<b>Title - Sujet</b> CCG WP 2.0 Construction	
<b>Solicitation No. - N° de l'invitation</b> EB144-182527/A	<b>Amendment No. - N° modif.</b> 001
<b>Client Reference No. - N° de référence du client</b> EB144-18-2527	<b>Date</b> 2018-02-14
<b>GETS Reference No. - N° de référence de SEAG</b> PW-\$PWA-405-5718	
<b>File No. - N° de dossier</b> PWA-7-78131 (405)	<b>CCC No./N° CCC - FMS No./N° VME</b>
<b>Solicitation Closes - L'invitation prend fin at - à 02:00 PM on - le 2018-02-27</b>	<b>Time Zone</b> <b>Fuseau horaire</b> Atlantic Standard Time AST
<b>F.O.B. - F.A.B.</b> <b>Plant-Usine:</b> <input type="checkbox"/> <b>Destination:</b> <input checked="" type="checkbox"/> <b>Other-Autre:</b> <input type="checkbox"/>	
<b>Address Enquiries to: - Adresser toutes questions à:</b> Kendell (PWA), Byron	<b>Buyer Id - Id de l'acheteur</b> pwa405
<b>Telephone No. - N° de téléphone</b> (902) 402-9436 ( )	<b>FAX No. - N° de FAX</b> (902) 496-5016

**Amendment 001 is raised for the following:**

Revised Level 300 layout as per attached sketches.

Public Works and Government Services Canada	Travaux publics et Services gouvernementaux Canada	Drawing title  ADDENDUM # 1 LEVEL 300 FURNITURE PLAN		designed

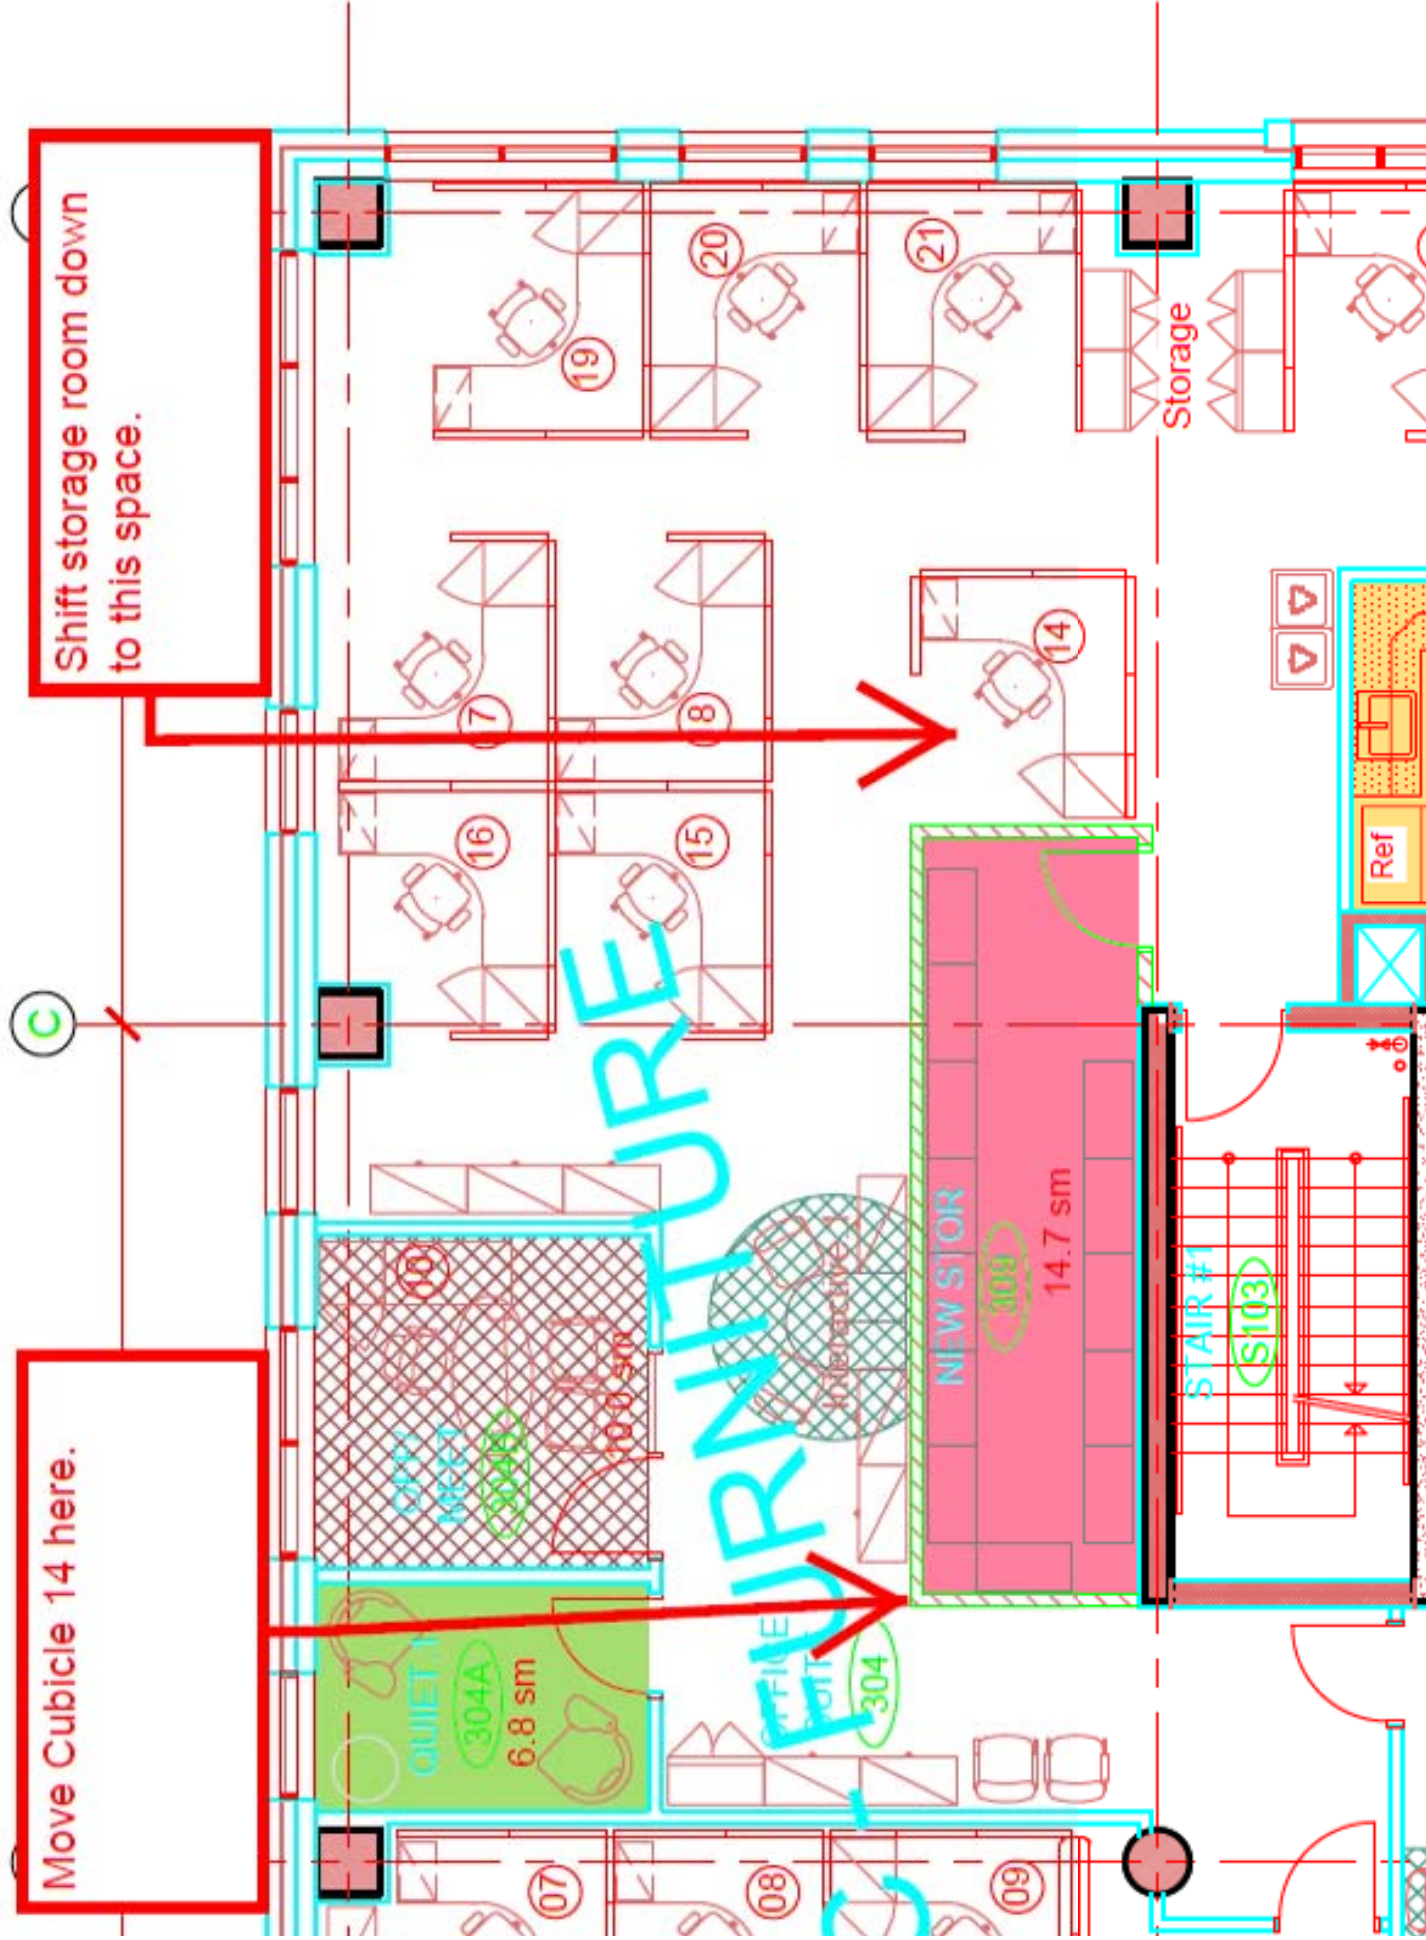
Move Cubicle 14 here.

Shift storage room down to this space.

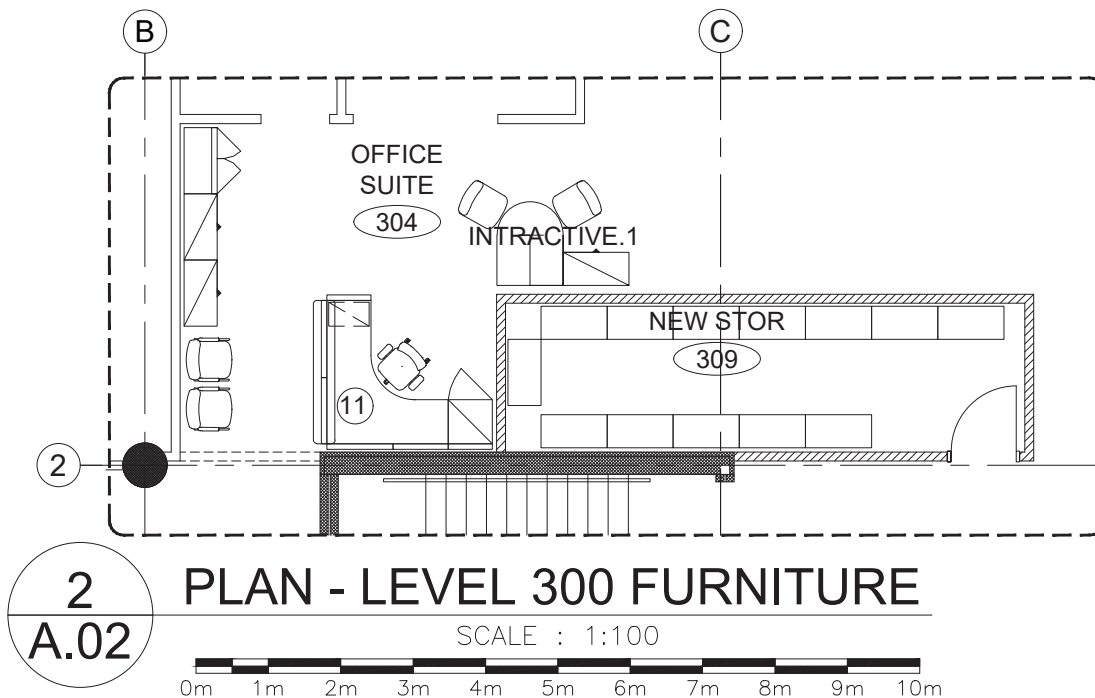
A) WORKSTATIONS # 11, 12 AND 13 ON LEVEL 300 AT GRID LINE C2 ARE TO BE DISMANTLED AND STORED IN A SECURE PLACE. WORKSTATIONS ARE TO BE REASSEMBLED. FINAL FLOOR/POSITION TO BE DETERMINED.

B) WORKSTATION #11 IS TO BE DISMANTLED AND STORED IN A SECURE PLACE DURING CONSTRUCTION OF THE NEW 308 STORAGE ROOM. ONCE THE LEASEHOLDS ARE COMPLETE THE WORKSTATION IS TO BE REASSEMBLED IN THE SAME LOCATION BY THE FURNITURE INSTALLER.

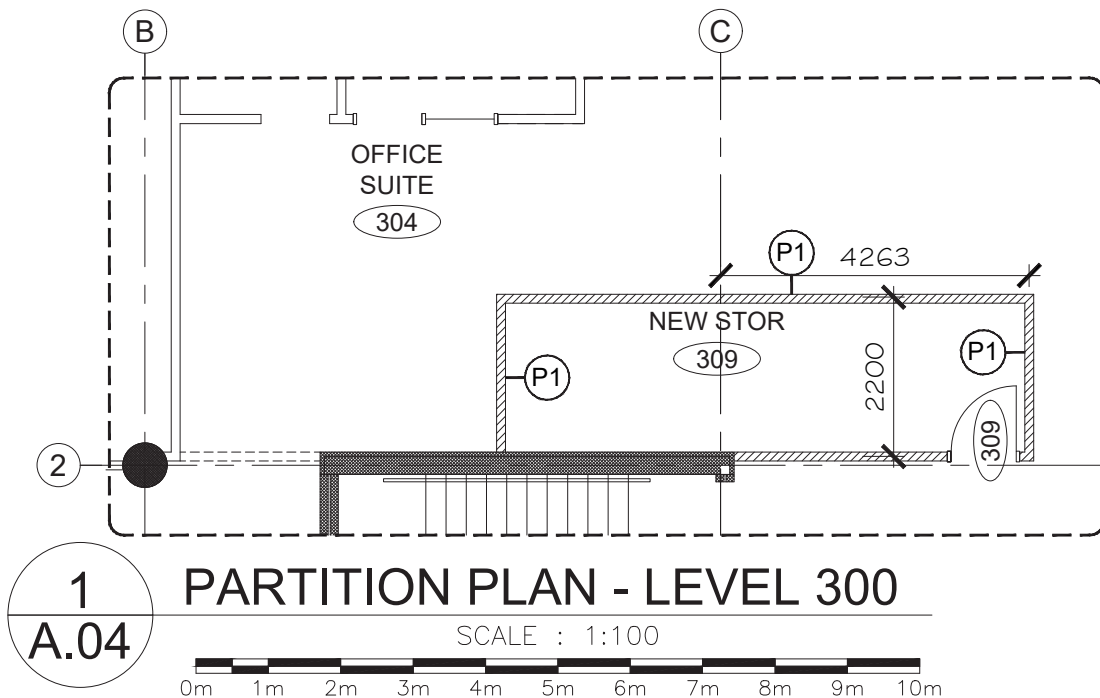
RELOCATE NEW STORAGE ROOM 2463mm  
EASTWARD AS INDICATED.

EAST WALL TO ALIGNED WITH EAST CORRIDOR  
WALLS DEFINING SERVERY AND NEW MEETING  
ROOMS.

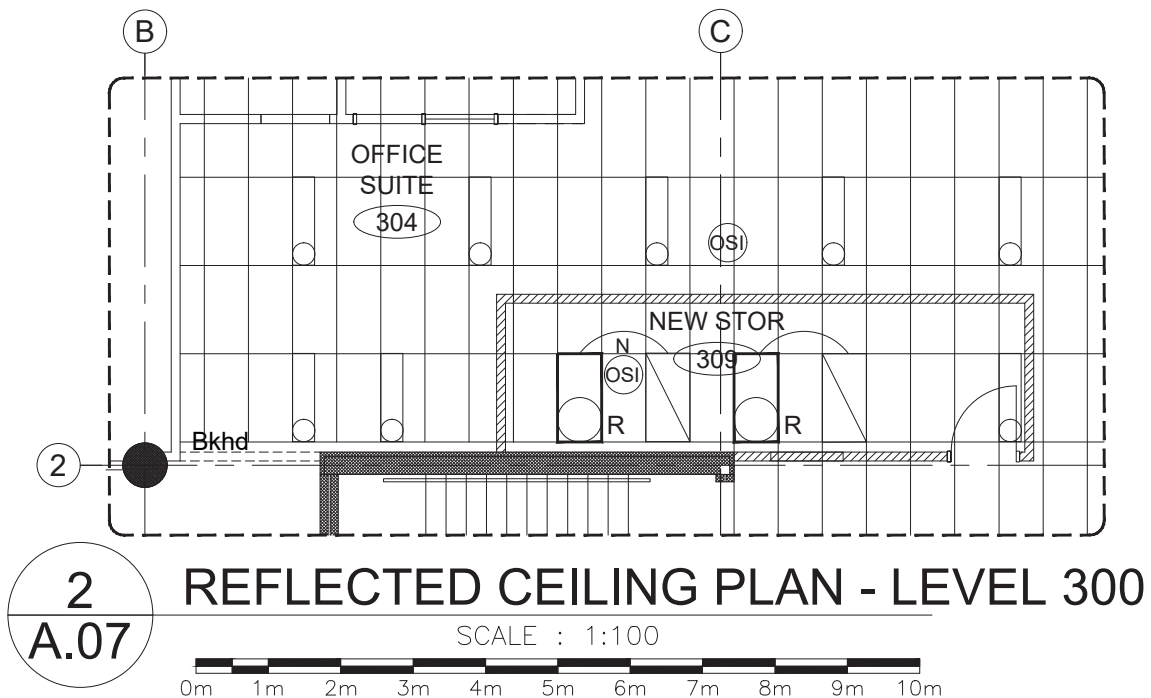
RELOCATE / REUSE LUMINAIRES AFFECTED BY THE  
RELOCATION OF THE NEW STORAGE ROOM  
EASTWARD.

REFER TO ELECTRICAL DRAWINGS FOR SPECIFICS.

**1 PARTIAL LEVEL 300 FLOOR PLAN - LIGHTING**  
**ESK.1A**  
 SCALE : 1:100  
 0m 1m 2m 3m 4m 5m 6m 7m 8m 9m 10m

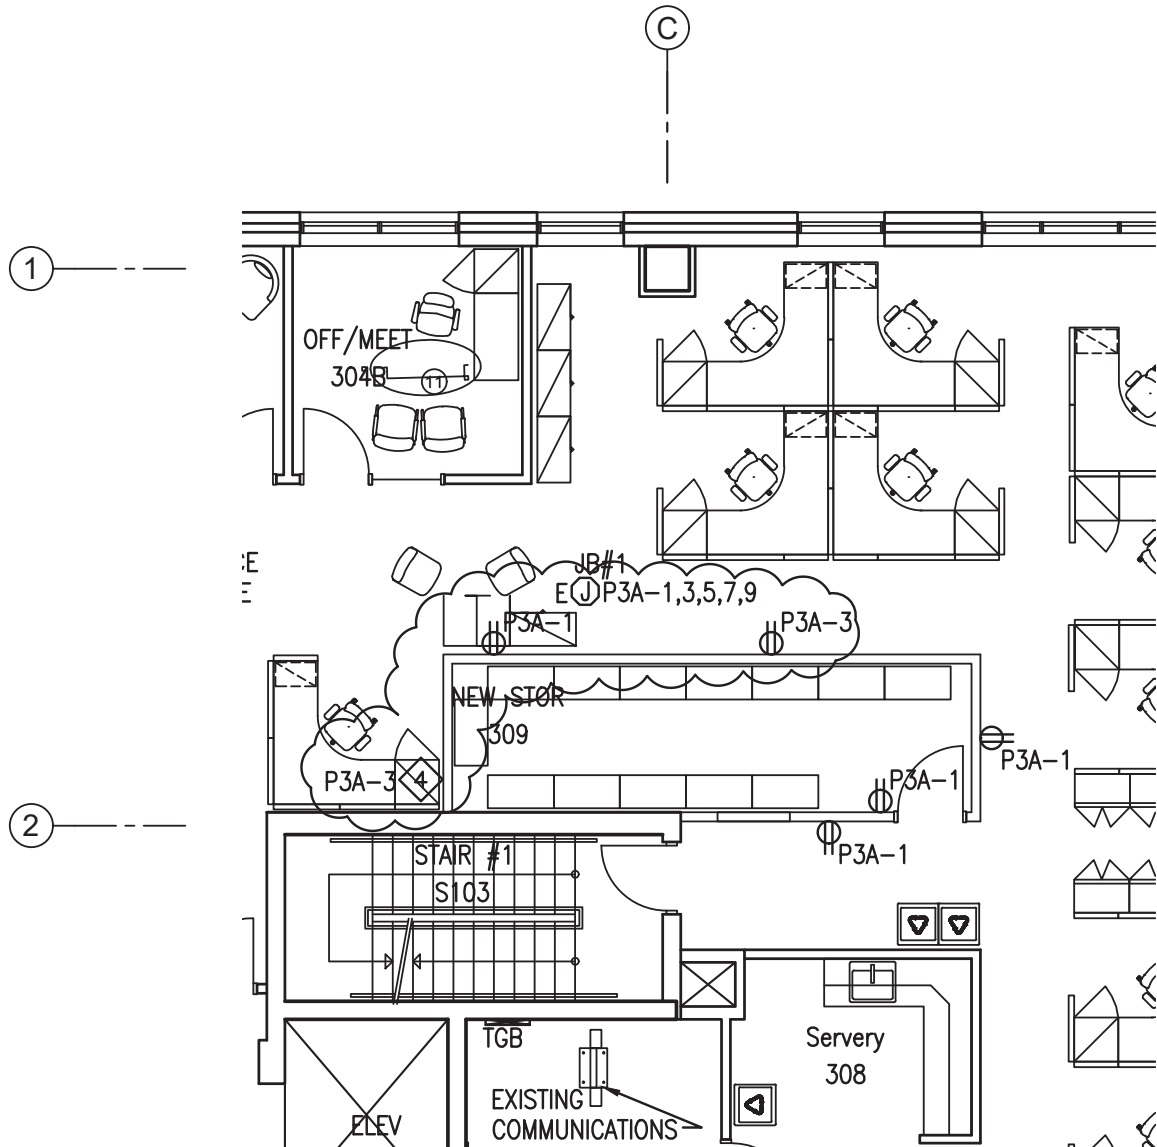
- 1 DISCONNECT AND REMOVE EXISTING LIGHTING WITHIN DASHED IN AREA.  
 MAINTAIN CIRCUIT CONTINUITY TO ALL REMAINING DEVICES.
